Addendum No.2
to
CONSTRUCTION DOCUMENTS
for

June 2, 2025
2023159.00

NCISD New District Administration Building
21330 Valley Ranch Parkway
New Caney, TX. 77357
June 2, 2025

A-504

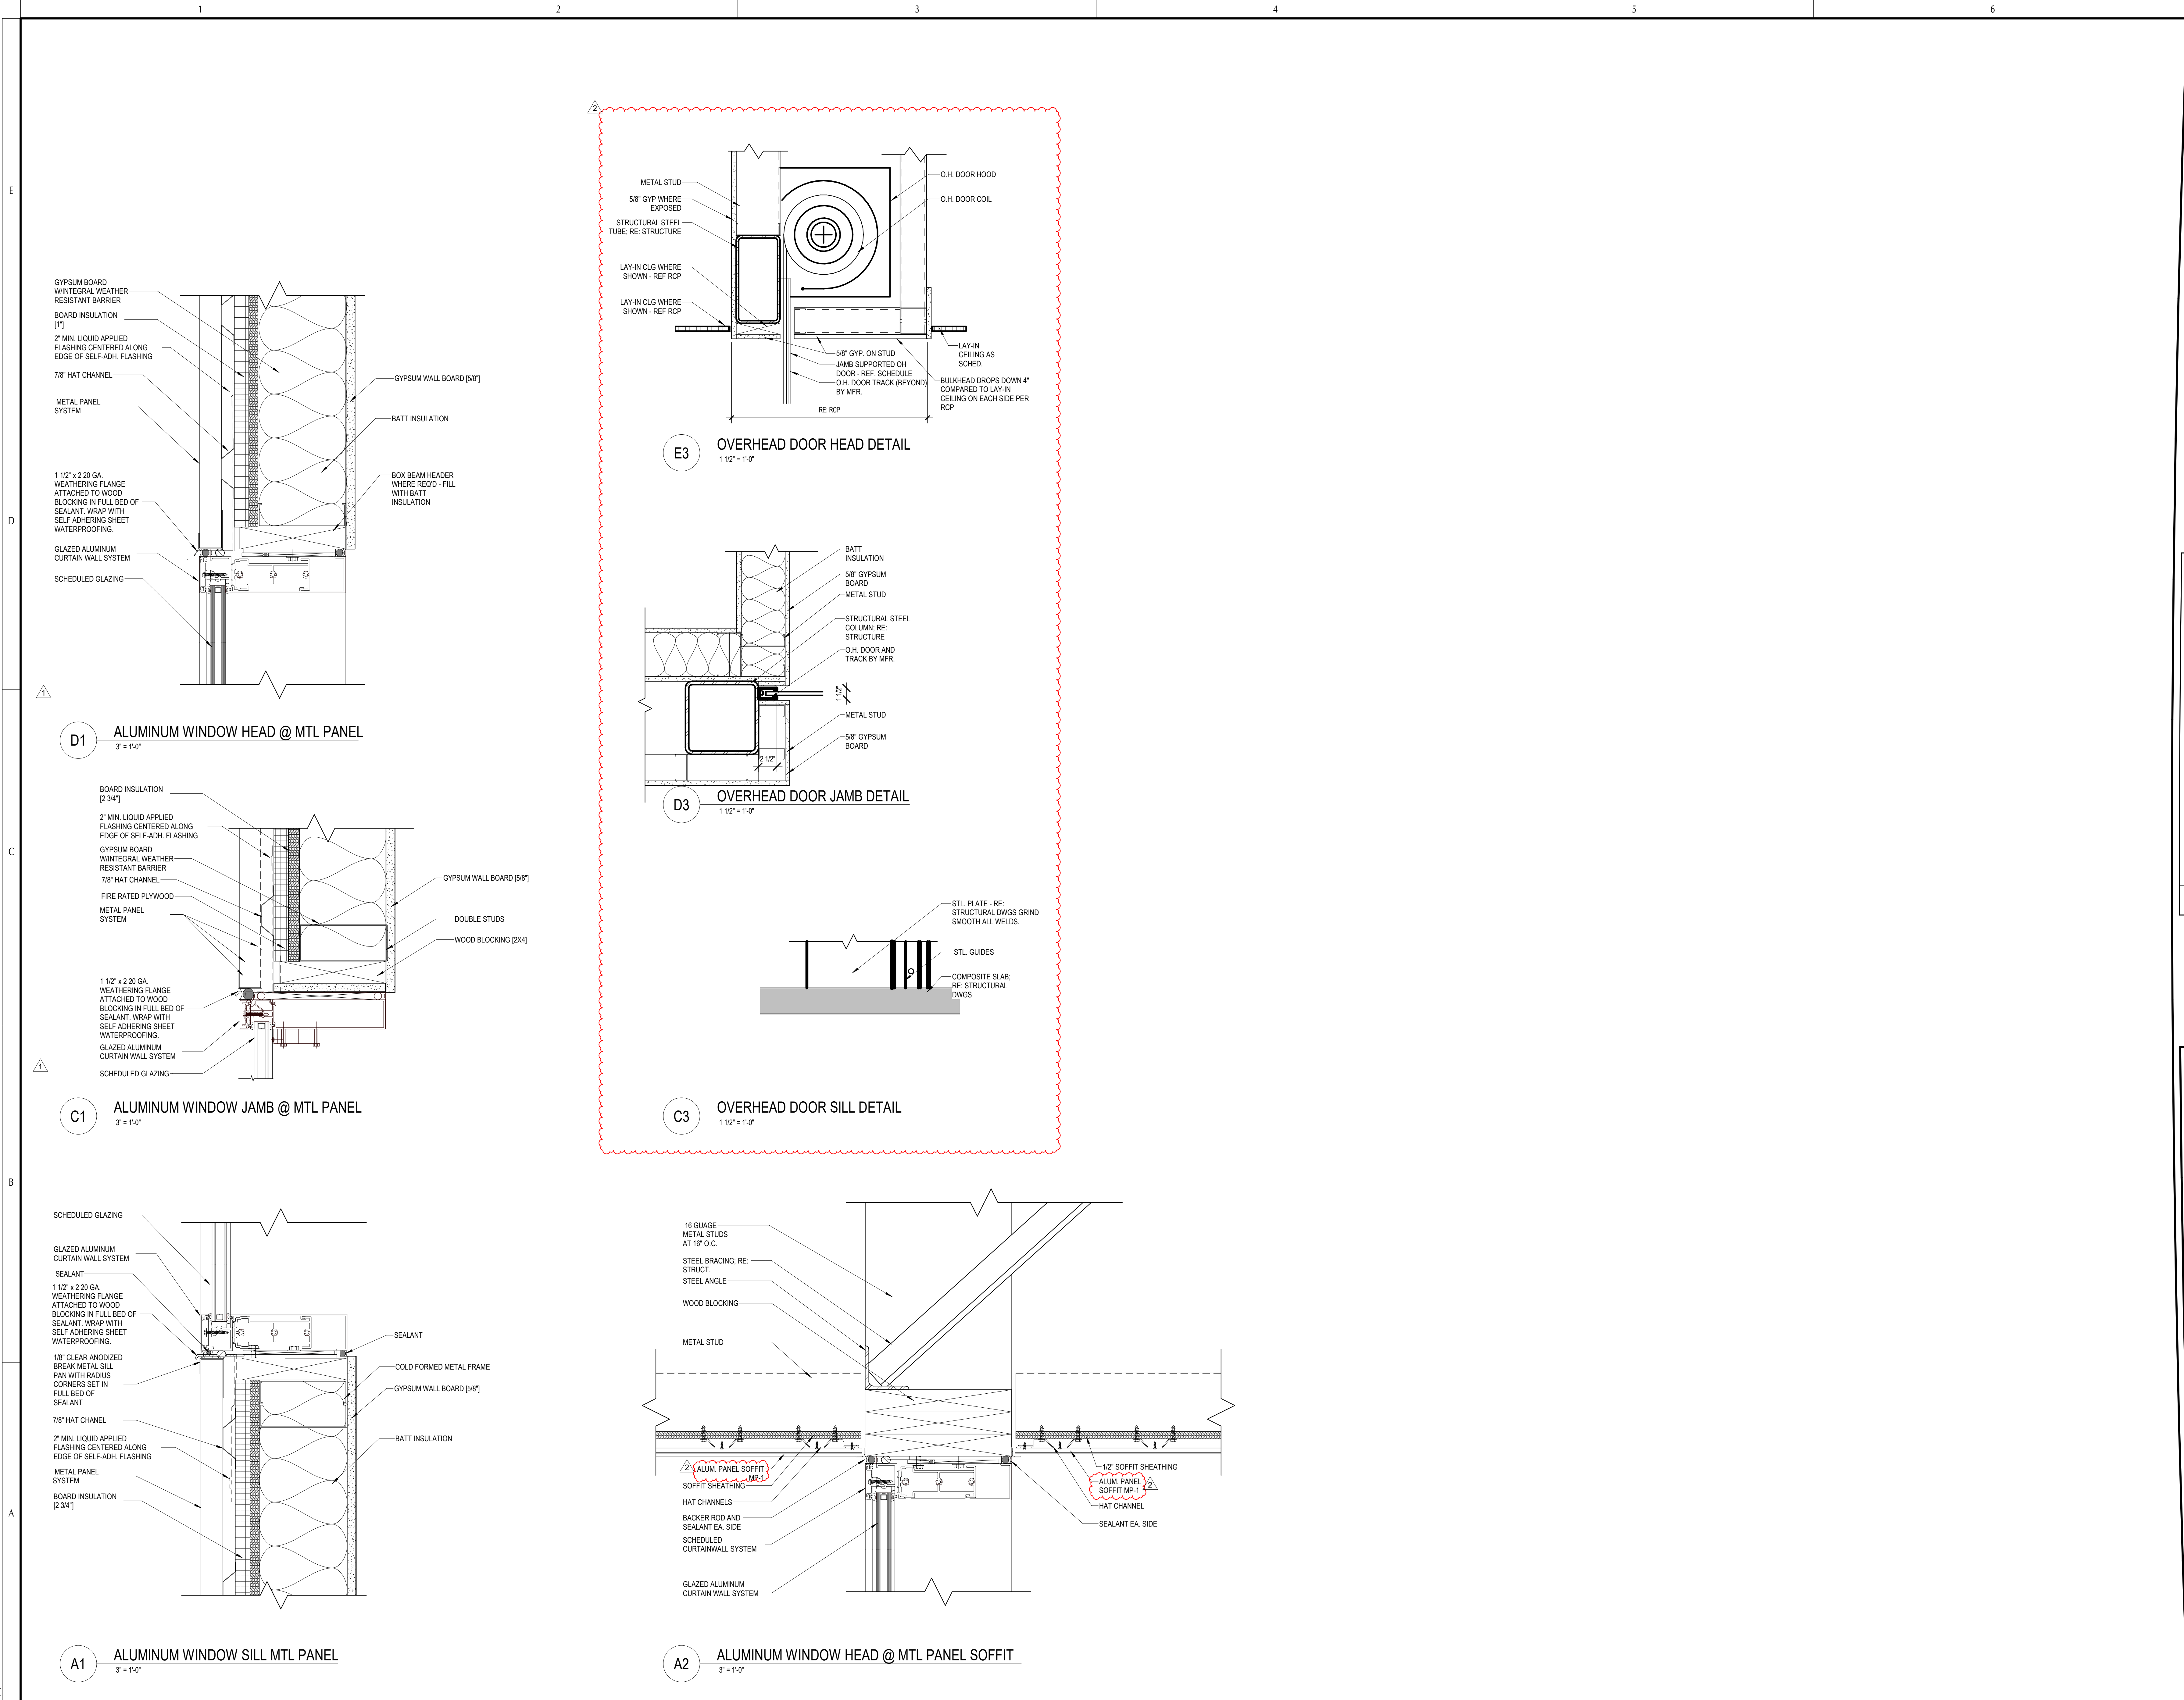
42. Sheet A-503 – Door and Window Details
- a. Refer to revised detail D1/A-503.
43. Sheet A-504 – Door and Window Details
- a. Revised plaster soffit ceiling structure to be painted plaster metal lath – 5/8" gypsum board sheathing, 3 5/8" metal studs on wall section detail D6/A-504.

A-508

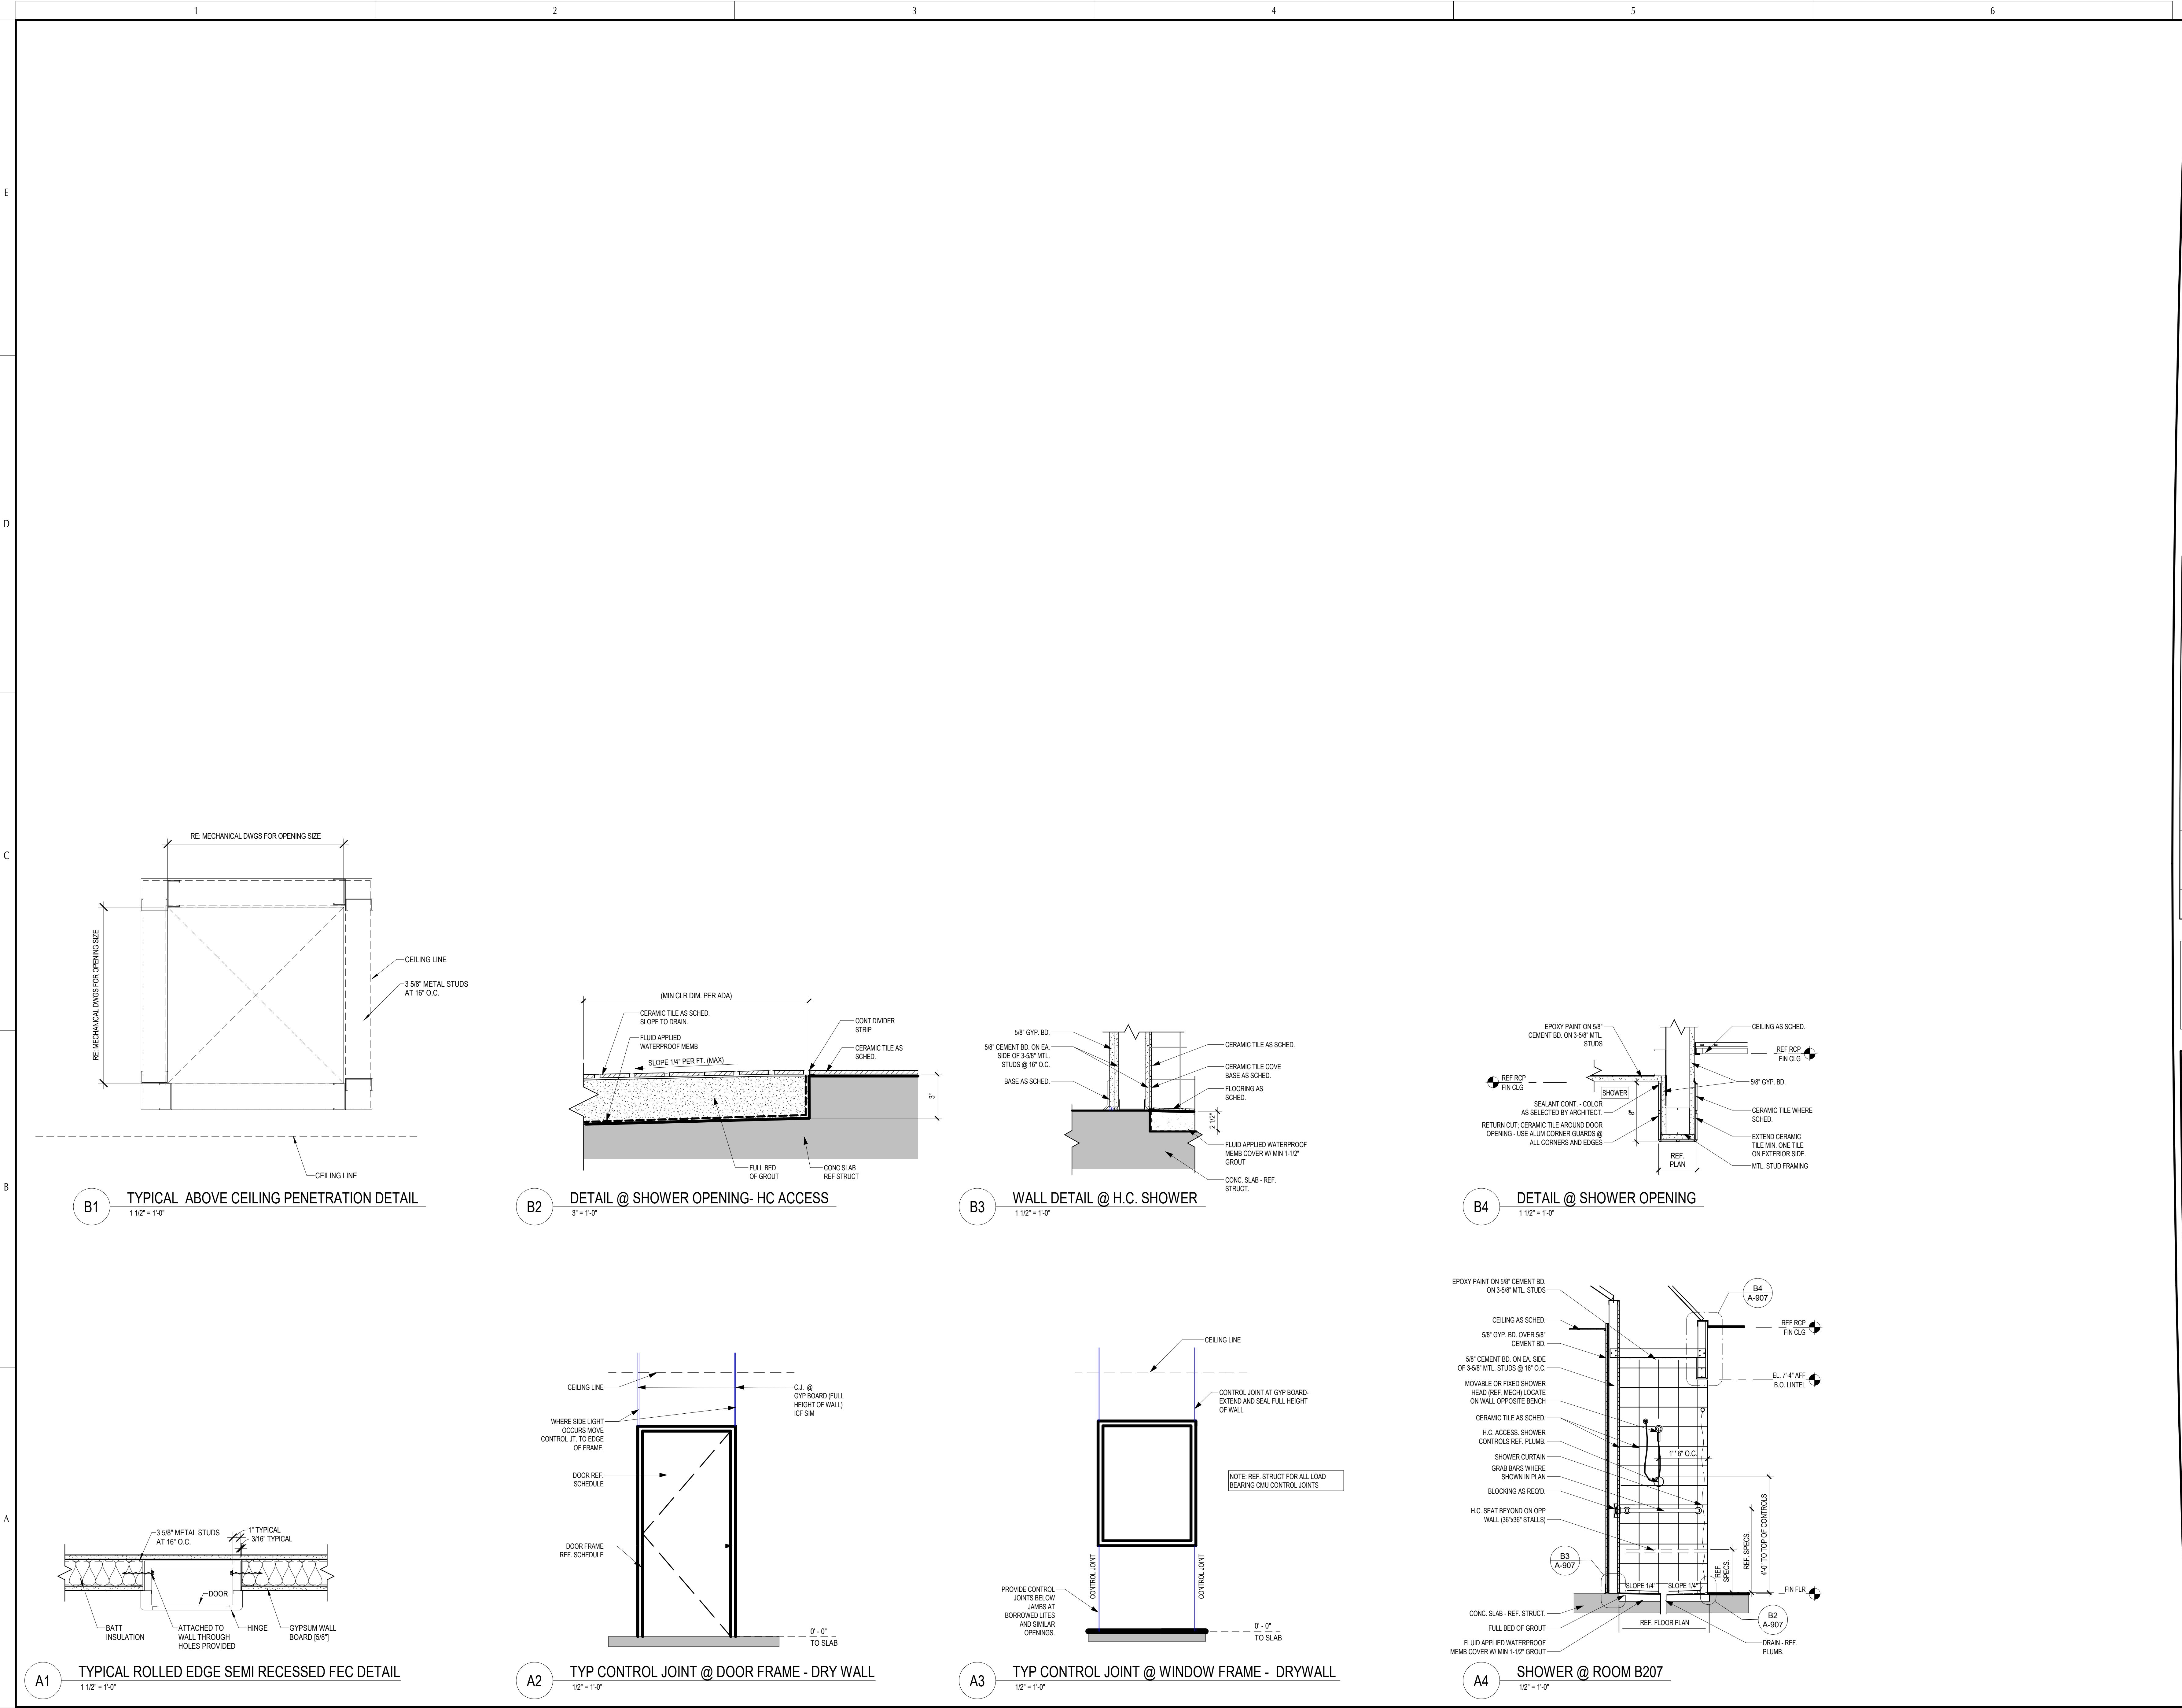
- 46. Sheet A-508 – Reflected Ceiling Plan Details
 - a. New sheet added in its entirety.
- 47. Sheet A-906 – Plan Details – Second Floor
 - a. Added plan detail D1 9A106/A107 – Plan Detail) Called out from the enlarged stairs A106 & A107

A-907

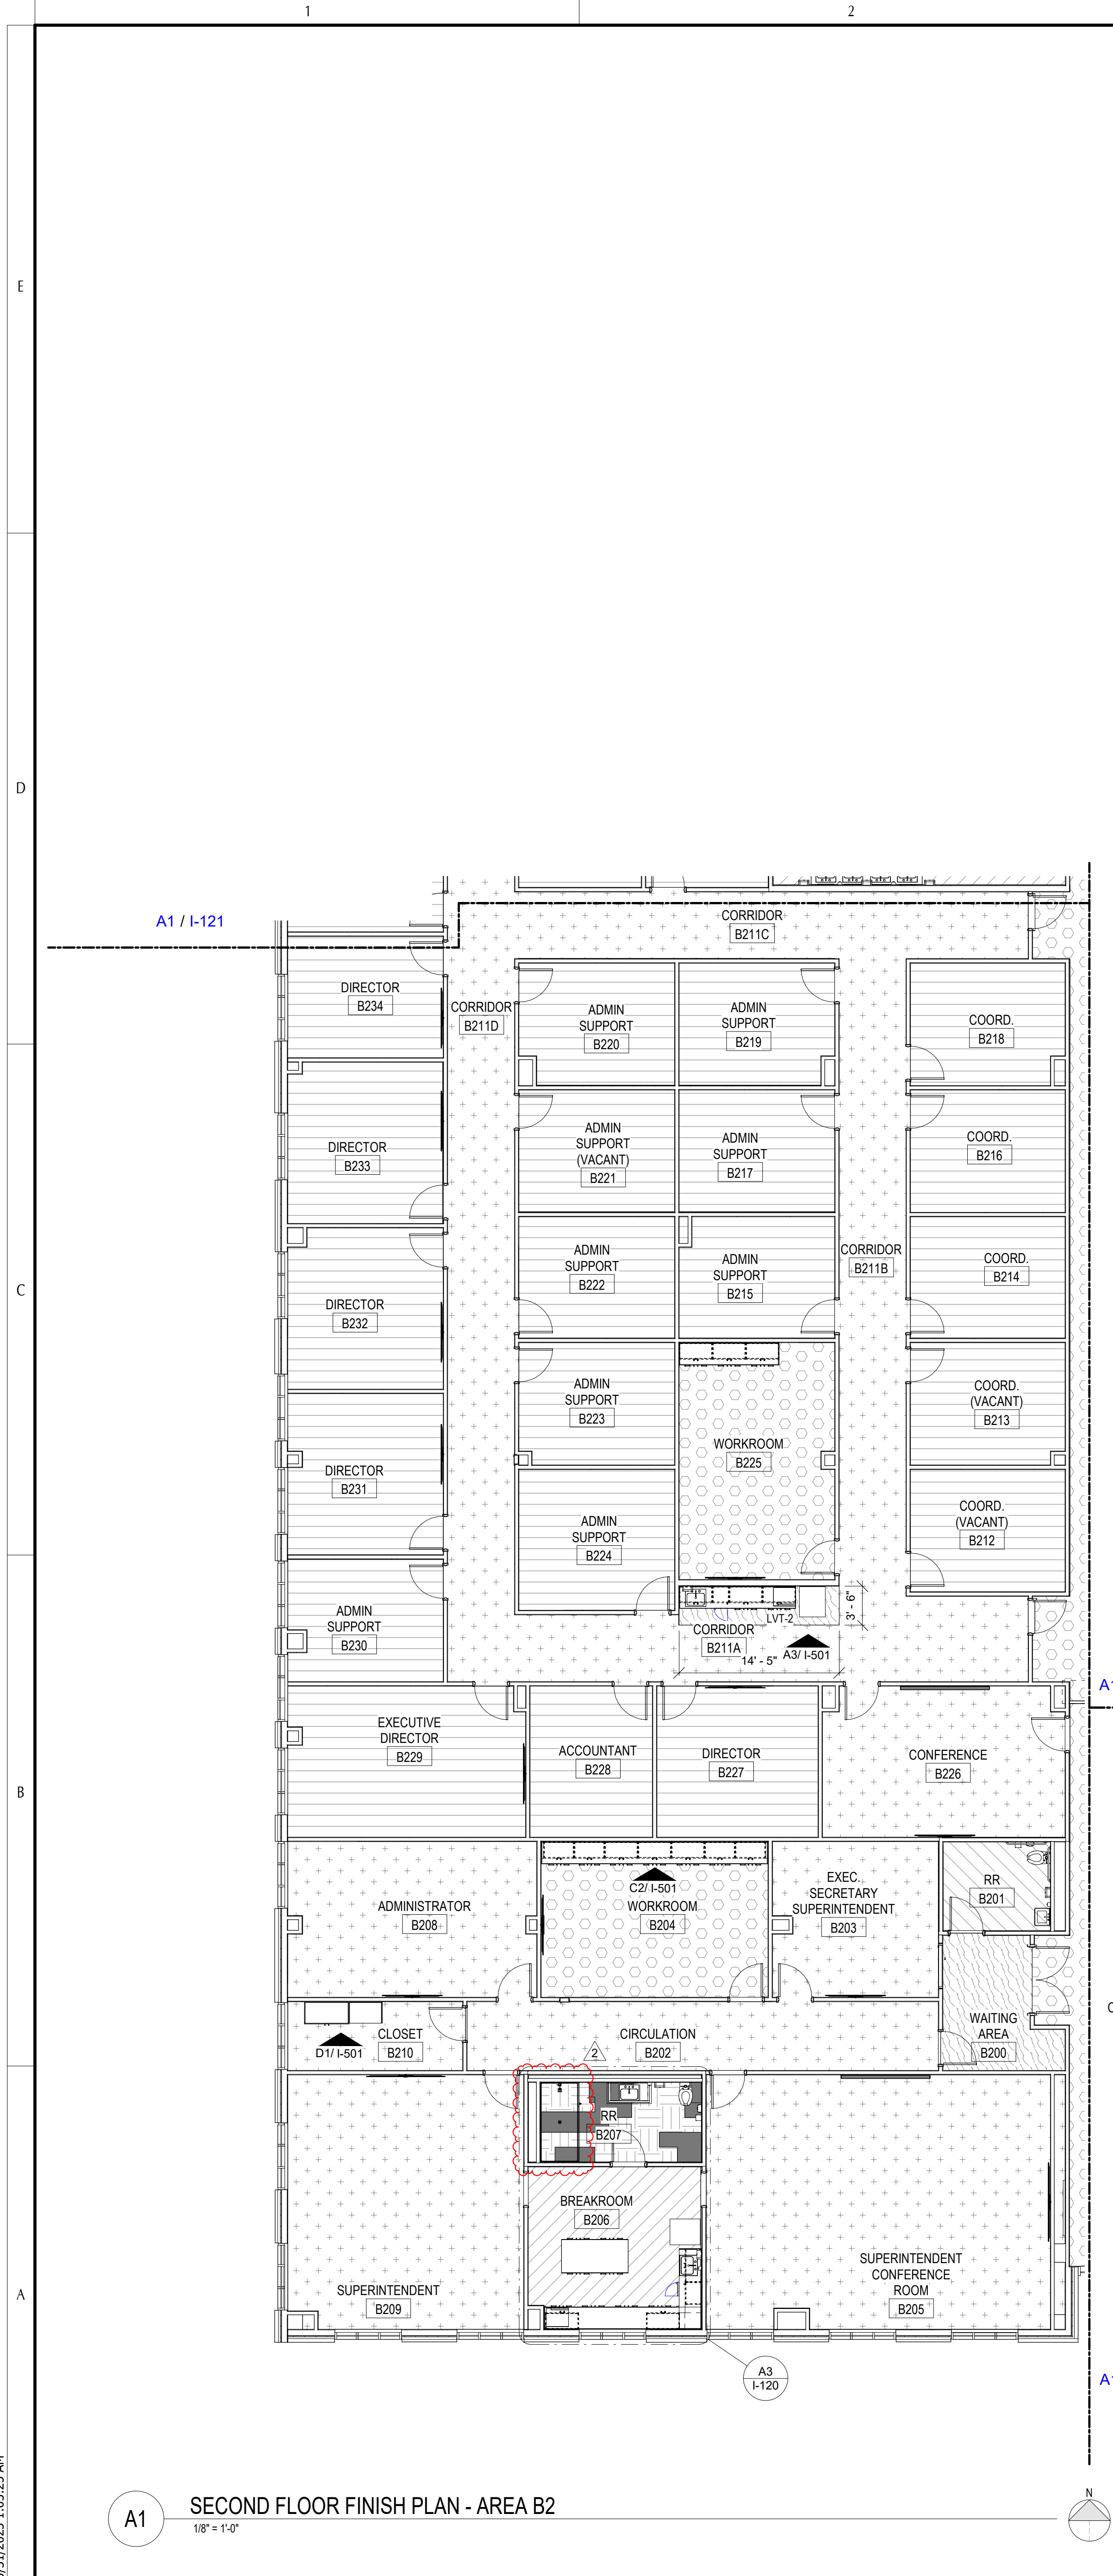
- 48. Sheet A-907 – Typical Details
 - a. New sheet added in its entirety.
- 49. Sheet I-114 – First Floor Finish Plan – Area D1
 - a. Room Finish Schedule Area D1
